ATTENTION: Document Control Desk
SUBJECT: Calvert Cliffs Nuclear Power Plant
Unit Nos. 1 & 2; Docket Nos. 50-317 & 50-318
Electrical Distribution System Functional Inspection, Combined Inspection
Report Nos. 50-317/92-80 and 50-318/92-80

REPLY TO A NOTICE OF VIOLATION
INSPECTION REPORT NOS. 50-317/92-80 AND 50-318/92-80

graph [1]

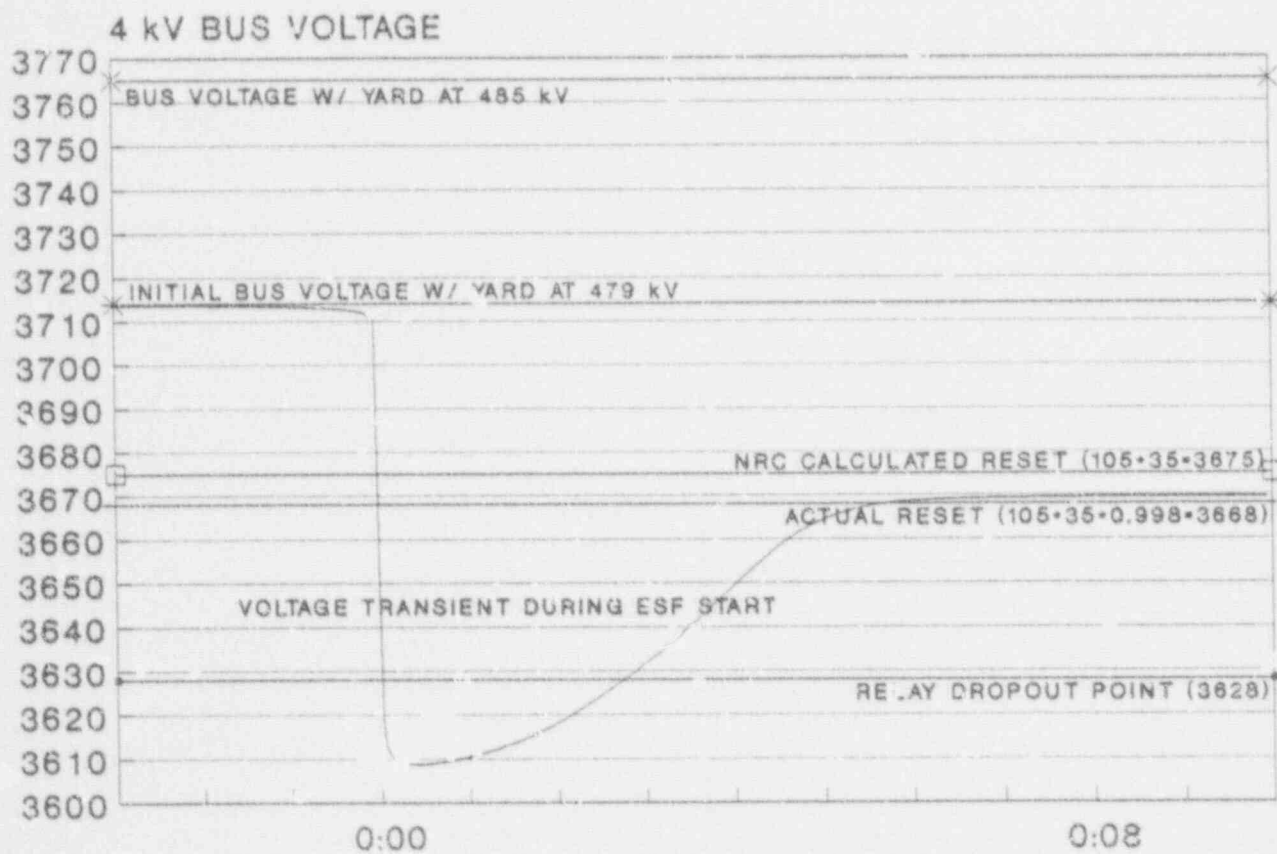
The EDSFI inspection report states that Calculation E-90-31 determined the reset voltage to be 3668 volts. The report also indicates that this correlates to a reset setting of 104.8 volts. Therefore the report concludes that the recorded reset setting of 105.0 volts is unsatisfactory.

BG&E wishes to clarify these observations. First, the methodology used in the NRC inspection report to convert from reset setting to 4 kV bus voltage omits the use of PT error. This causes discrepancies between the NRC values and the values in use.

Second, Calculation E-90-31 did not determine 3668 volts to be the reset point or "the worst case 4160 bus running voltage" as stated in the report. Rather, the calculated reset setting of 105.0 volts discussed above was equated to a 4 kV bus voltage of 3668 volts. That number was then used as an input to calculate the minimum acceptable switchyard voltage necessary to clear the maximum reset setting following an Engineered Safety Features actuation (limiting case transient) under worst case conditions. This switchyard voltage was found to be 479 kV and would result in a final steady state 4 kV bus voltage of 3668.5 volts. (See attached graph [1])

By including PT error, it becomes clear that 105.0 volts corresponds to 3668 volts on the 4 kV bus. It is an acceptable setting for the relay reset.

In summary, Calculation E-90-31 was done expressly to determine the minimum initial switchyard voltage required to clear the maximum reset setting for the limiting case transient. Switchyard voltage is controlled above that value with conservatism
